QUEEN CREEK/SANOKAI WASH HYDRAULIC MASTER PLAN

FCD 98-26

ADMINISTRATIVE REPORT MEETING MINUTES

MEETING MINUTES

Location of Main Branch of Sanokai Wash

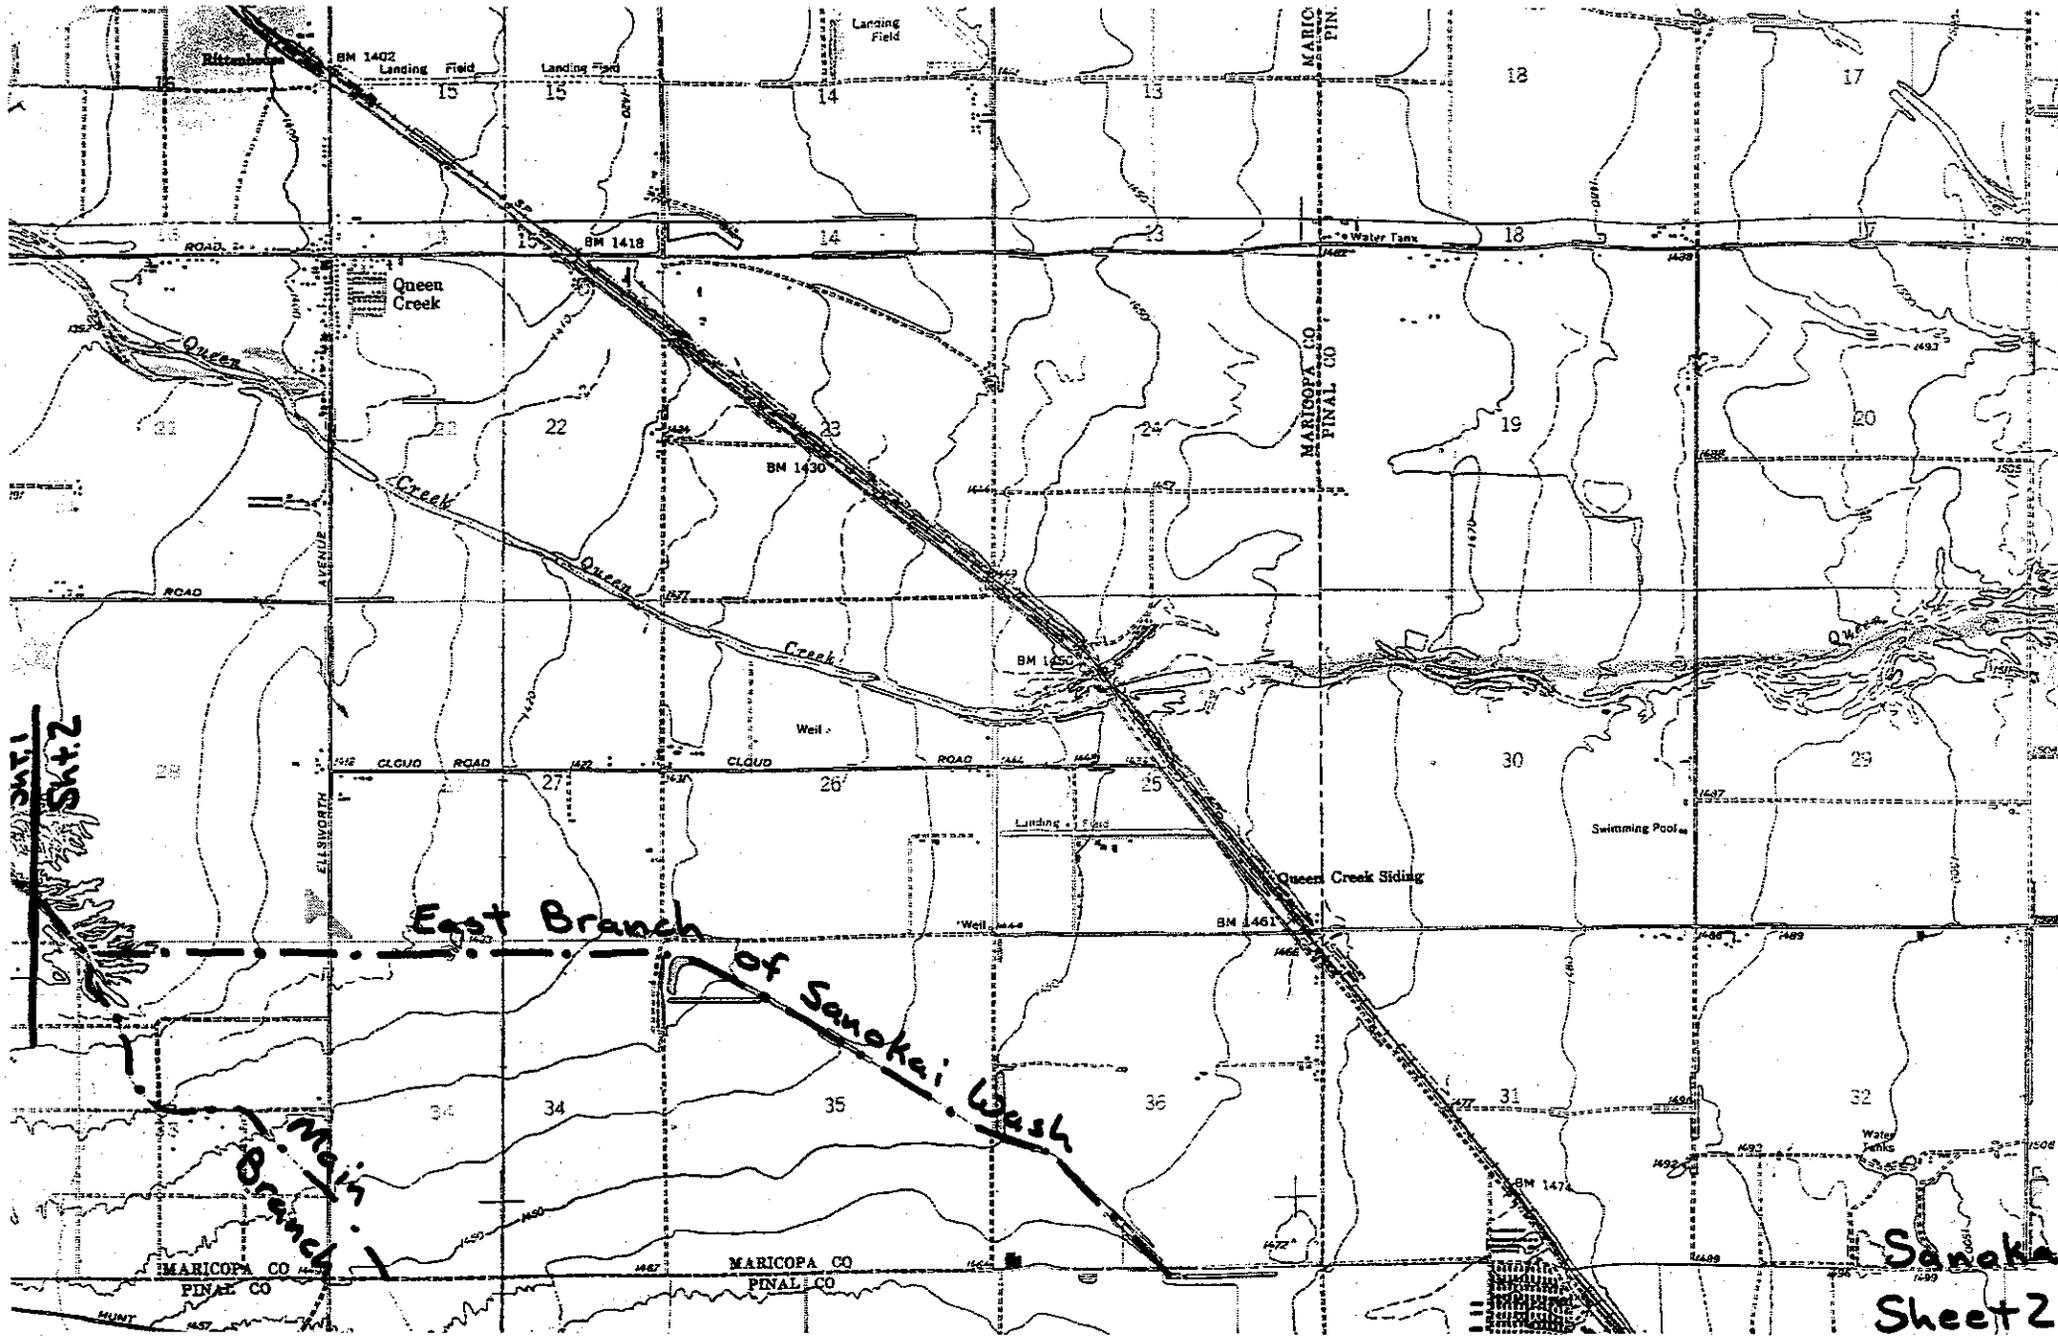
Fred asked the District to provide guidance as to the preferred alignment of the Main Branch of Sanokai Wash between Hunt Highway and Riggs Road. He provided a handout showing the alignment as originally agreed to by the District earlier in the project (attached). Based on input from Dick Schaner, the existing channel of the Main Branch of Sanokai Wash in this area is poorly defined. However, field observation and review of maps and aerial photographs indicate that this channel alignment passes through a newly developing area of manufactured homes. Dick suggested that it would be preferable to re-align the Main Branch in this area to go north from the mid-east/west line of section 33 to join the East Branch near the northerly boundary of section 33. Tim said he would review the matter and get back to Huitt-Zollars with a decision.
